# Planning and Zoning Commission Meeting

PRELIMINARY DEVELOPMENT PLANS  
FOR  
HIGH COUNTRY  
PHASE 10

RE: Comment Response to Preliminary Plat Review  
High Country Phase 10 – Preliminary Plat

**Planning and Zoning Commission Meeting  
Staff Report  
January 9, 2025**

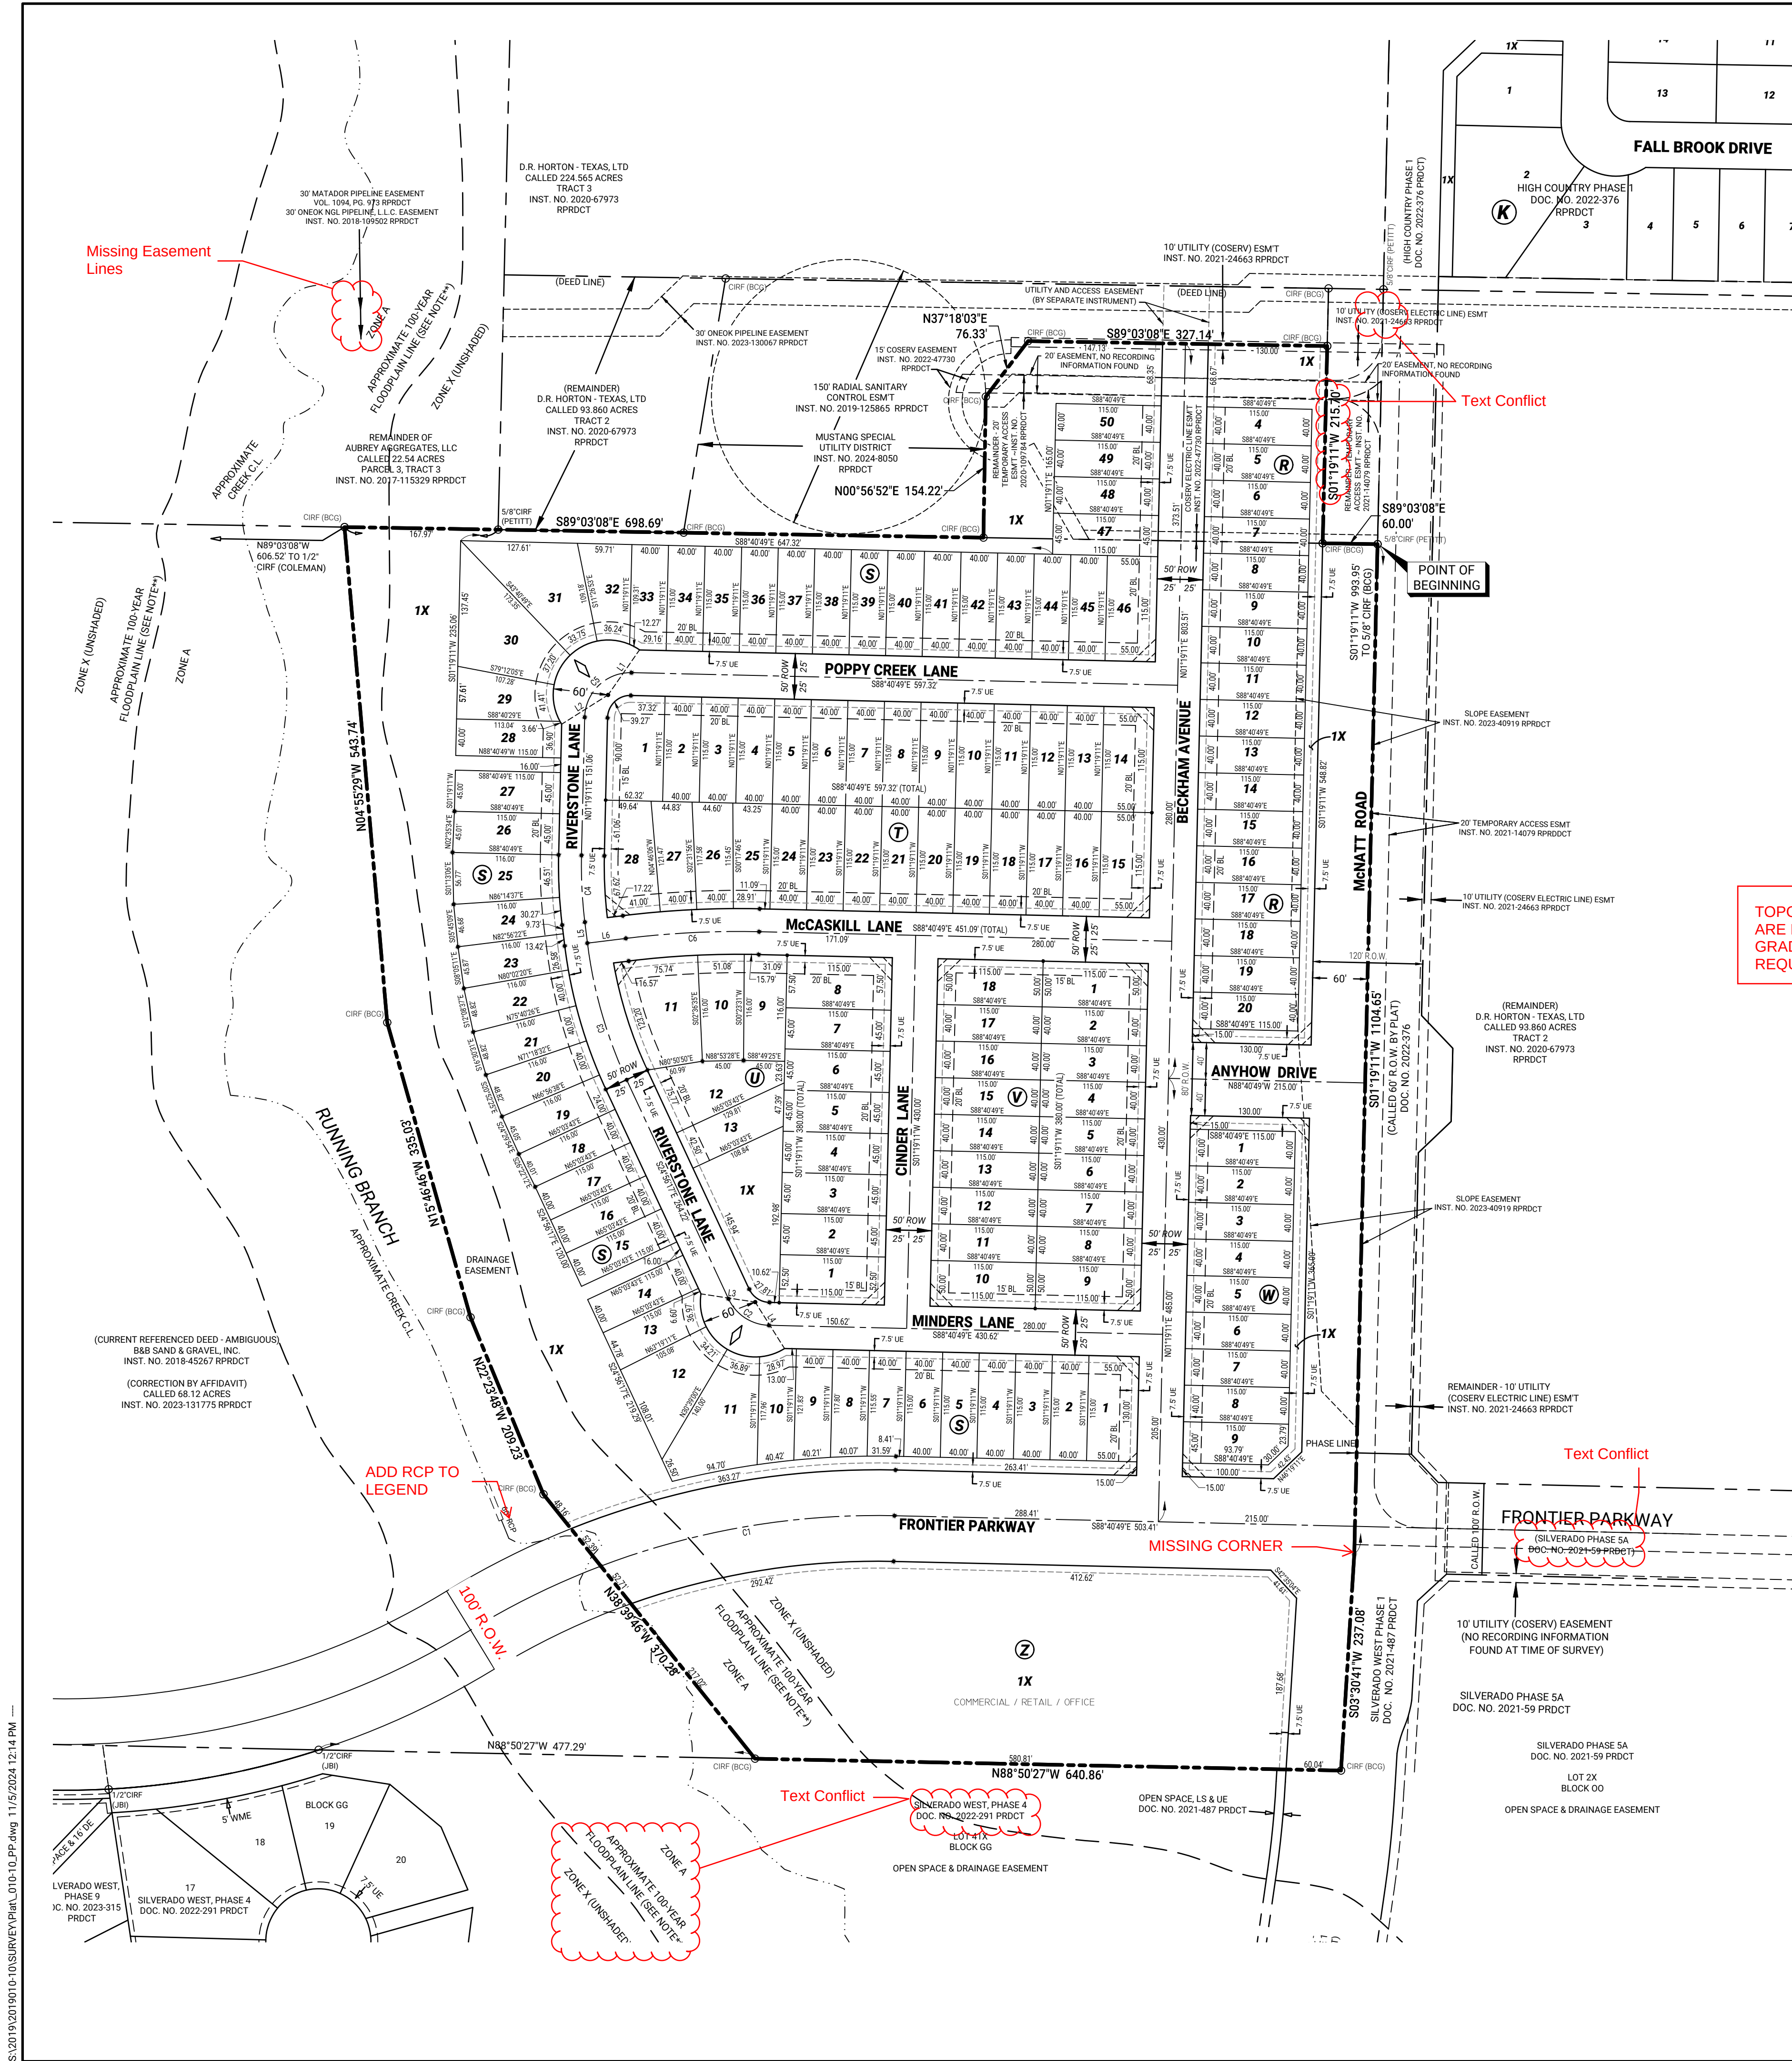
1. All the materials and plans specified within section 1.05 shall be submitted for review in order for an application to be considered complete. <https://ecode360.com/40429714>

3. Has this access easement been completed? Will it temporarily dead-end?
  - a. **This access easement has been prepared and is under review by Mustang. Recording of the easement will be added to the plat before the plat is filed.**

4. Will a screening wall be placed along this lot line/where lots back to McNatt and Frontier? If so, provide a 5 foot WME to the HOA.
  - a. **Yes, there will be a screening wall placed along the lot lone/ where lots back to McNatt and Frontier.**

- a. **No, the street names are placeholder for now and will be finalized once approved by Denton County.**
9. On Lot 1X, Block Z, remove X designation. X designation is reserved for Open Space type lots. Rename Lot 1, Block Z as "General Retail Lot".

14. Note #8, Identify Easements on the lots.
  - a. **Addressed. Easements have been identified as requested.**
15. Note #7, Second sentence: Add: "Ownership and" to beginning of sentence.
  - a. **Addressed. "Ownership and" has been added to the beginning of sentence as asked.**
16. Have the following items been submitted for review, as required with a Preliminary Plat? preliminary water and sanitary sewer layout preliminary drainage plan. If utilizing a previously approved drainage plan, include the accepted plan. Drainage plan may also include the preliminary Storm Water Management Site Plan, preliminary Storm Water Management Site Plan (SWMSP).
  - a. **Documents submitted with this resubmittal**

17. Remove "X" from Lot 1X, Block Z – Lot Area.
  - a. **"X" has been removed from Lot 1X, Block Z – Lot Area.**

18. Missing Easement Lines.
  - a. The plat has been updated to show the Missing Easement Lines for Matador.
19. Fix the Text Conflict between the 10' UTILITY (COSERV ELECTRIC LINE) ESMT INST. NO. 2021-24663 RPRDCT and S01°, 19'11" W 215.70'.

22. Text Conflict at (Silverado Phase 5A Doc. No. 2021-59 PRDCT).
  - a. Text Conflict at (Silverado Phase 5A Doc. No. 2021-59 PRDCT) has been resolved and the sheet has been updated.

- a. Acknowledged.
24. Add RCP to legend.
  - a. Text has been removed – plat should not show improvements.
25. 100' ROW
  - a. Addressed. 100' ROW label has been added as requested.

27. Missing right side line on District Approval Stamp.
  - a. Addressed. Right side line on District Approval Stamp has been added and the Stamp has been updated.

28. Note #15: Are distances shown in grid or surface?
  - a. Addressed. Note#15 updated (surface)
29. Owner's Certification: 2<sup>nd</sup> Paragraph shows "BCG 10194538", but plat shows "Pettit Cap".
  - a. Addressed. Owner's Certification: 2<sup>nd</sup> Paragraph has been updated to show "PETTIT" and matches what plat shows.
30. Owner's Certification: 5<sup>th</sup> Paragraph should be 60.04 feet?
  - a. Addressed. Owner's Certification: 5<sup>th</sup> Paragraph has been updated to show 60.04 feet.
31. Owner's Certification: 7<sup>th</sup> Paragraph – add "to a 5/8" iron rod".
  - a. "Said iron rod" refers to the 5/8-inch rod mentioned above. Correct as written.
32. Owner's Certification: 12<sup>th</sup> Paragraph – replace metes and bounds with "S 89 03' 08" E".
  - a. Owner's Certification: 12<sup>th</sup> Paragraph- metes and bounds has been replaced with "S 89 03' 08" E".

- a. **The Utility and Access Easement has been prepared and is under review by Mustang SUD. Recording of the easement will be added to the plat before the plat is filed.**

- a. **X designation has been removed as asked.**
  - b. **Lot 1, Block Z has been named "General Retail" as requested.**
10. Reminders: Landscape, irrigation, and screening plans are required with civil plans.

1. Provided by our third-party consultants, Birkhoff, Hendricks, & Carter (see attached).  
Topographical information with contour lines are required for preliminary plats. Preliminary Grading, Water, and Sewer sheets are missing as per City requirements.
  - a. Topographical information with contour lines are provided in the preliminary storm plans
  - b. A Preliminary Civil Set has been submitted with Preliminary Grading, Water, and Sewer sheets as required.

1. All fire hydrants must have a 5" storz connection.
  - a. Entirety of Silverado/High Country was built with Mustang SUD's standard 5-1/4" main nozzle on FHs. Phase 10 can be done with 5" Storz if requested, please confirm that Aubrey FD wants this phase to be unique. Will be addressed in civil plans.

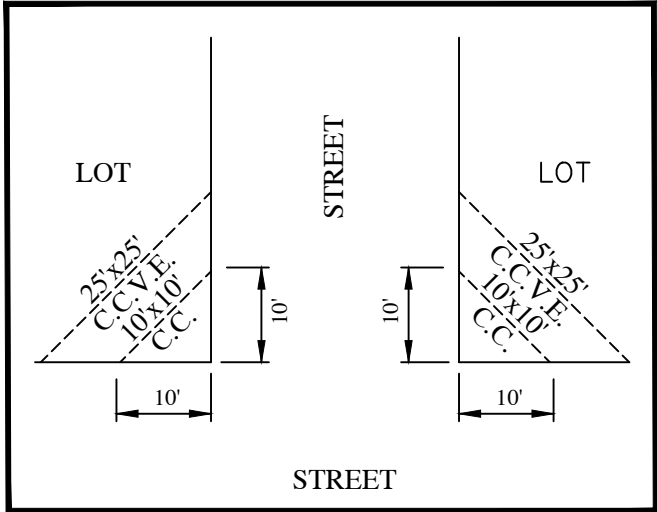
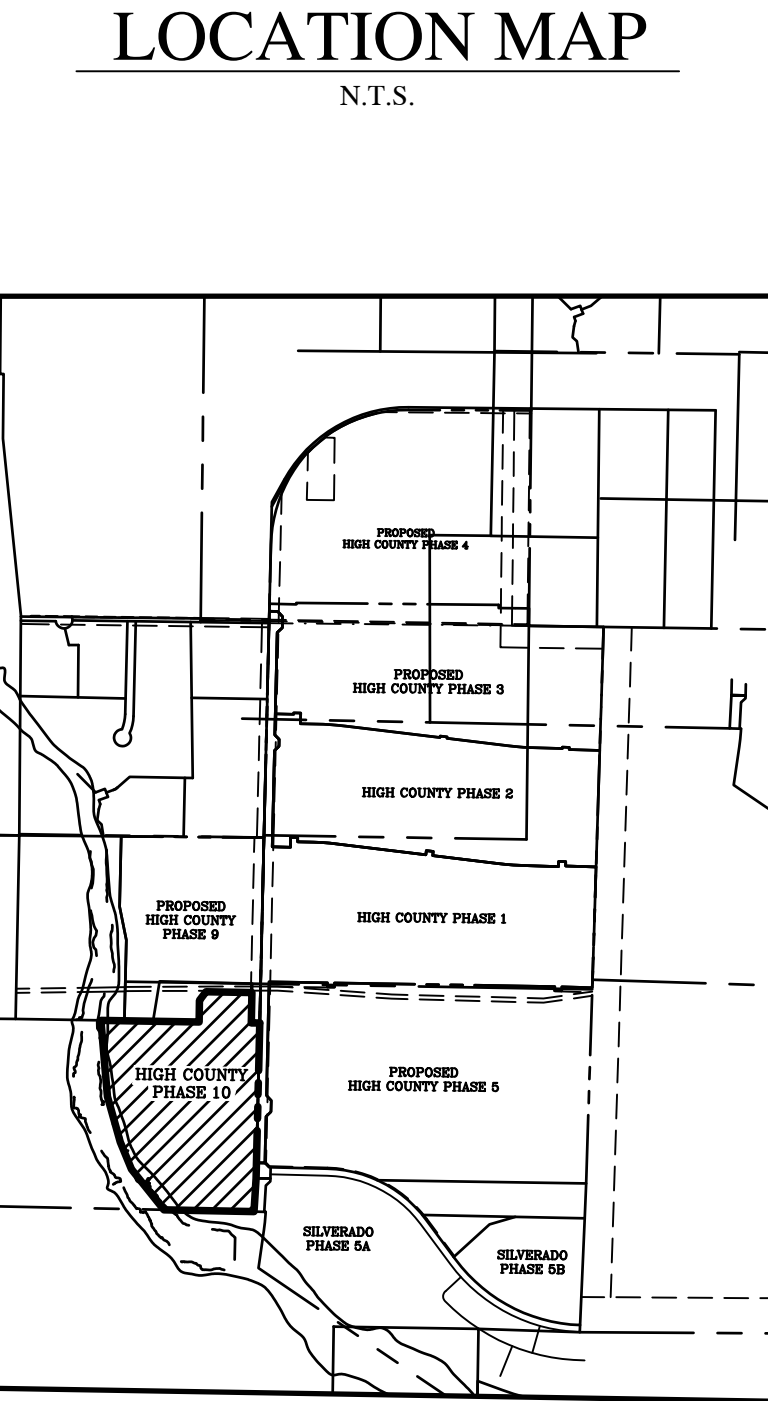
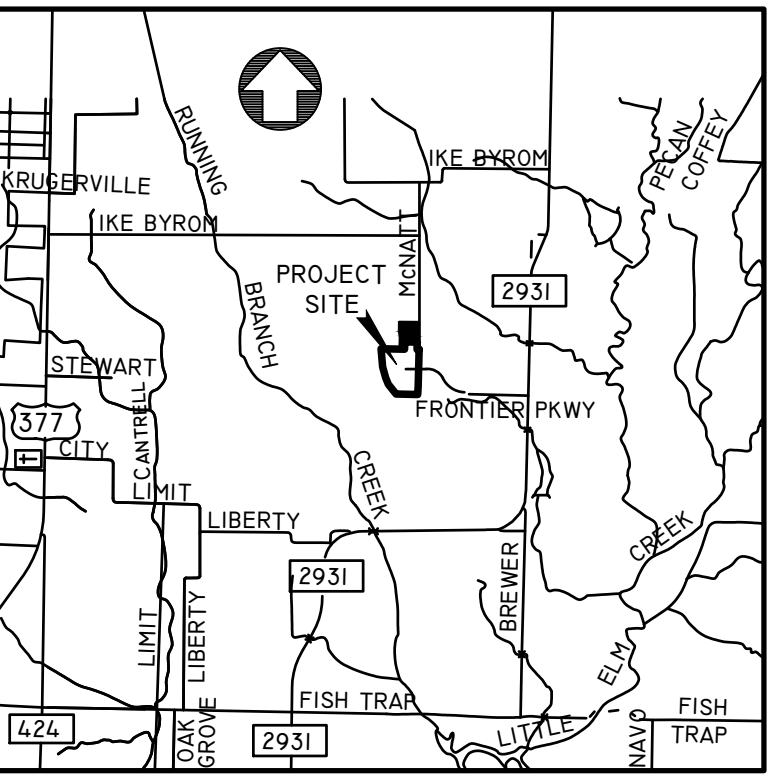
TOPOGRAPHICAL INFORMATION WITH CONTOUR LINES ARE REQUIRED FOR PRELIMINARY PLATS, PRELIMINARY GRADING, WATER, & SEWER SHEETS MISSING - PER CITY REQUIREMENTS

15. THE BEARINGS SHOWN AND RECITED HEREON ARE REFERENCED TO THE MONUMENTED EAST LINE OF HIGH COUNTRY PHASE 1, AN ADDITION TO DENTON COUNTY, TEXAS RECORDED IN DOCUMENT NO. 2022-376, PLAT RECORDS OF DENTON COUNTY, TEXAS (S01'48'23"W). ARE DISTANCES SHOW IN GRID OR SURFACE?
